# STAFF RECOMMENDATION

NCPC File No. 5907

## MARTIN LUTHER KING, JR. NATIONAL MEMORIAL TIDAL BASIN, WEST POTOMAC PARK Washington, D.C.

August 28, 2008

**LOCATION OF EIGHT BOLLARDS AT MEMORIAL'S FORECOURT**

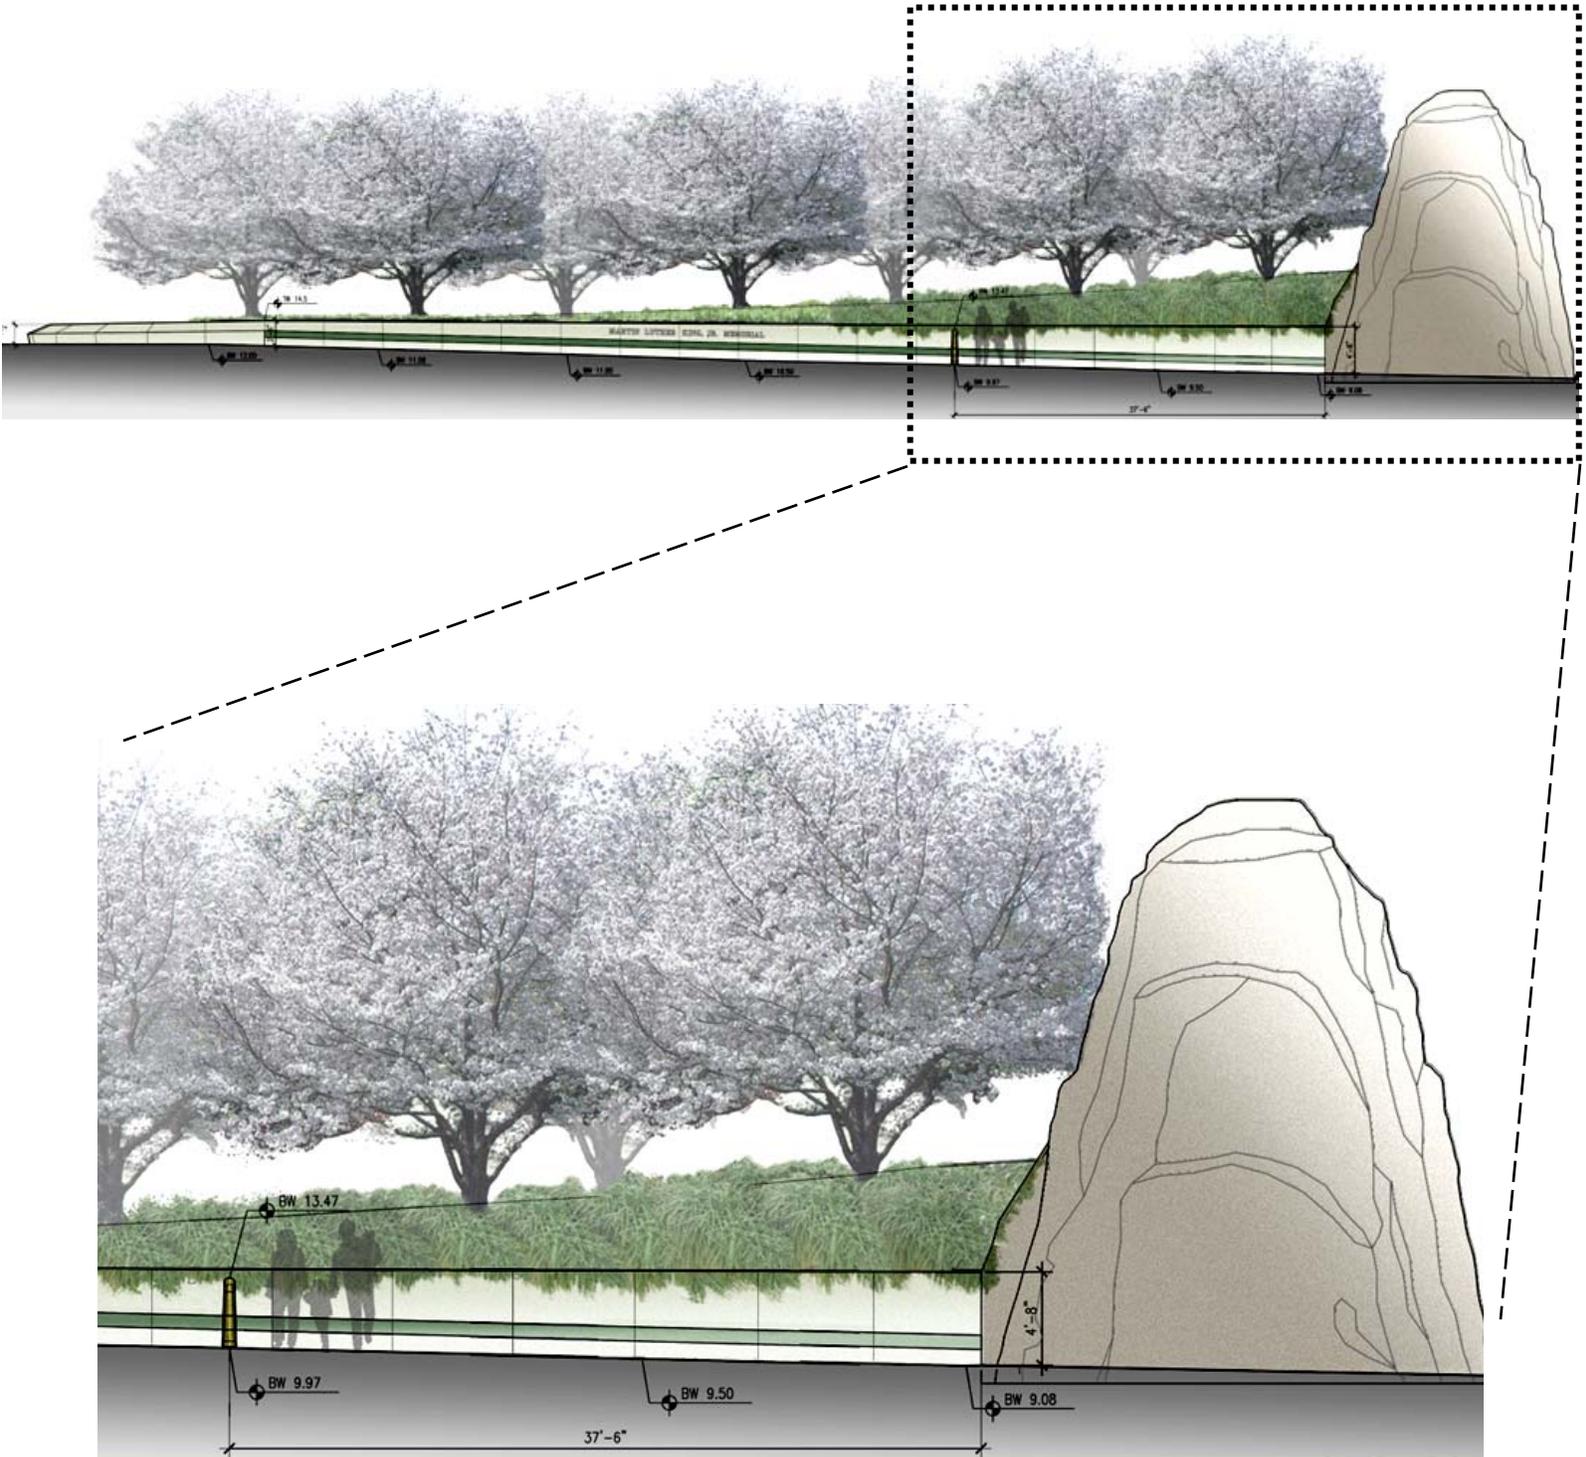
**recommends to the Commission that the information is inconclusive. Staff recommends that the Commission disapprove the proposed bollards at this time.**

Additionally, staff is unconvinced that inclusion of bollards as shown on the drawings will fully address the security concerns outlined by the applicant. Given this and given the potential visual and physical intrusion that the bollards will have upon the Memorial; staff at this time cannot support the placement of bollards in the Memorial's forecourt or side entry walkways. Also, additional information on the potential visual and physical effects of the bollards would assist the Commission in its decision-making.

**VISITOR SUPPORT BUILDING  
DETAILED FLOOR PLAN,  
WITH DONOR WALL  
HIGHLIGHTED AT RIGHT**

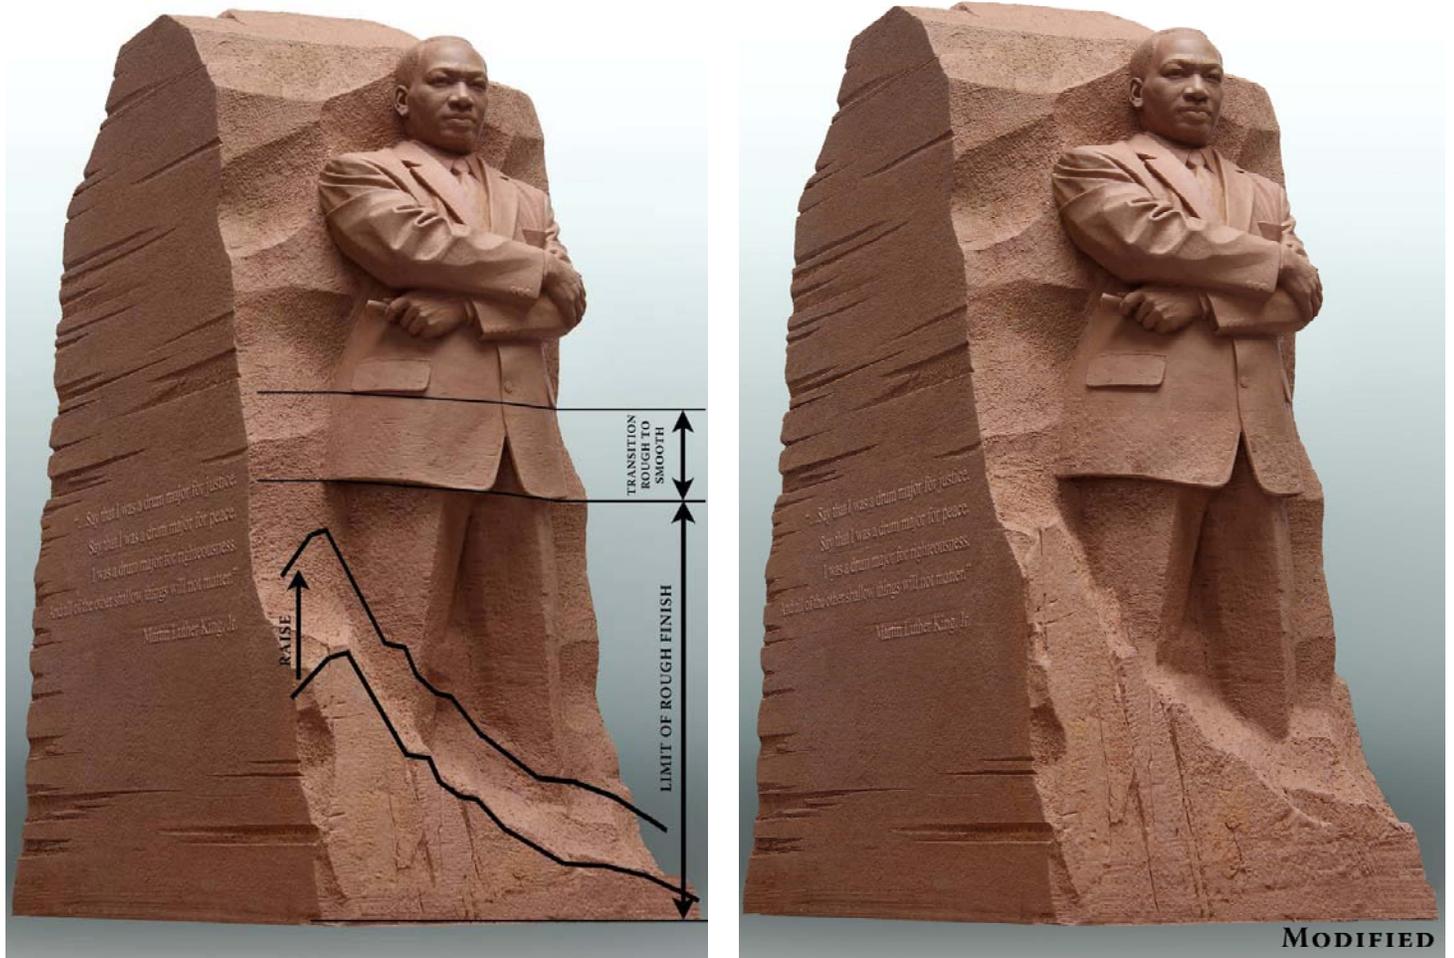
Staff finds the submitted project drawings of the preliminary and final design of the Martin Luther King, Jr. National Memorial are substantially complete to a 95 percent information level, with modifications fully noted. The final design details included in the submission for the building and many memorial features are highly refined and clearly noted. Staff continues to view the final design of the Visitor Support Building as light and simple in its material composition; subdued in its massing; and is appropriately located to best serve the memorial's visitors. Nevertheless, an issue remains with the structure that limits staff's ability to recommend final approval without modification. That issue is the presence of an interior donor wall located at the north end of the building within the bookstore. The existence of this feature is in direct conflict with the Commission's policies on donor recognition specified by the Commission in 1988. Specifically, the building's interior donor wall conflicts with policy 2 which cites: "Donor/sponsor contributions to memorials to be located on public lands in the National Capital shall not be visibly acknowledged anywhere at the memorial site, including in or on an associated memorial building," (see attachment). Furthermore and perhaps most significant, the Commemorative Works Act that directly applies to this memorial specifies at Section 8905, Site and design approval, (b) Decision Criteria, Item 7: "Donor contributions. - Donor contributions to commemorative works shall not be acknowledged in any manner as part of the commemorative work or its site." **Staff, consequently, finds the design and location of the interior donor wall within the Visitor Support Building unacceptable, and requests the Commission require the applicant remove the feature from the memorial project.**

- **Disapproves** the design and location of the interior donor wall within the Visitor Support Building and requires the applicant remove the feature from the memorial project in compliance with the Commemorative Works Act and the Commission's policies on donor recognition.

**EARLY CLAY MODEL OF SCULPTURE WITH MODIFICATIONS NOTED ON ORIGINAL IMAGE OF DR. KING AT LEFT**

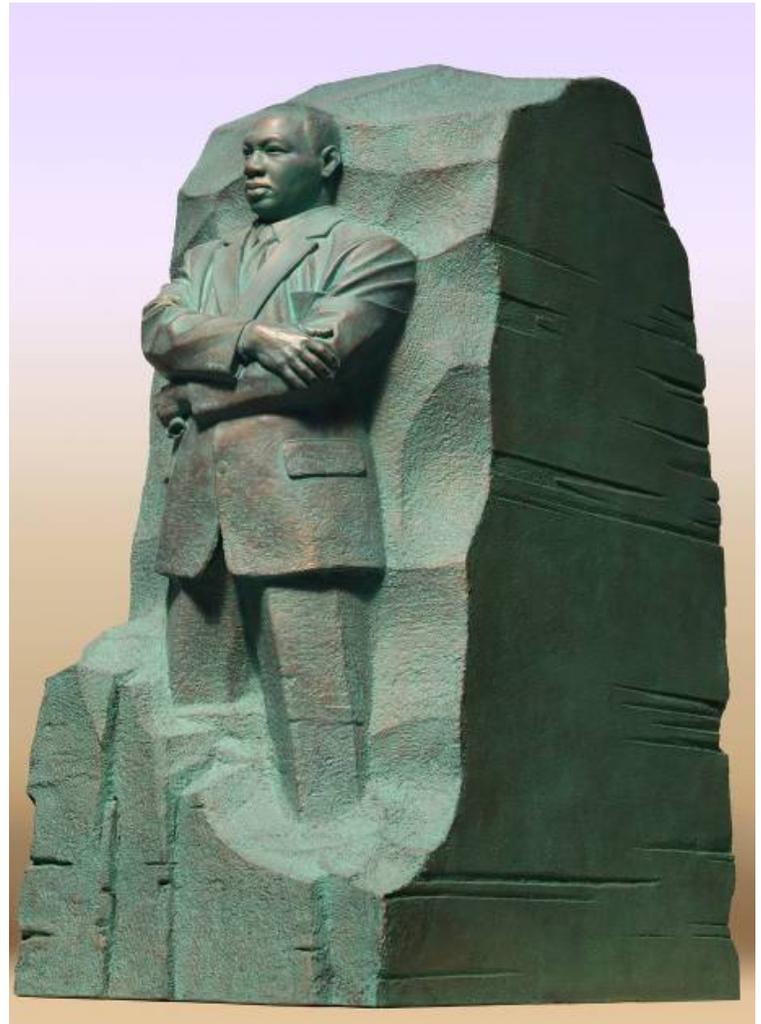
As noted by the earlier description of the sculpture issues in this report, the staff is pleased to observe the Foundation has submitted to NCPC the revised image for the *Stone of Hope* as requested. The revised *Stone of Hope* now depicts Dr. King's form in its same basic appearance of the figure of Dr. King with crossed folded arms at his chest. The image remains centered on the Tidal Basin side of the *Stone of Hope*. The edges of the sculpture are brought forward to

reduce the apparent amount of relief of the image thickness at its edges, and the base of the rough stone area has been elevated to just above the knee level of the figure on the left, as one views the figure. The sculpture also carries a rough stone appearance on the left and right side in the area of the suit-coat pocket. Finally, Dr. King’s face has been somewhat altered to remove some facial-lines around the mouth and cheek area of the head. **Images of the sculpture are revised and submitted, as requested, for final approval. Staff recommends their approval.**
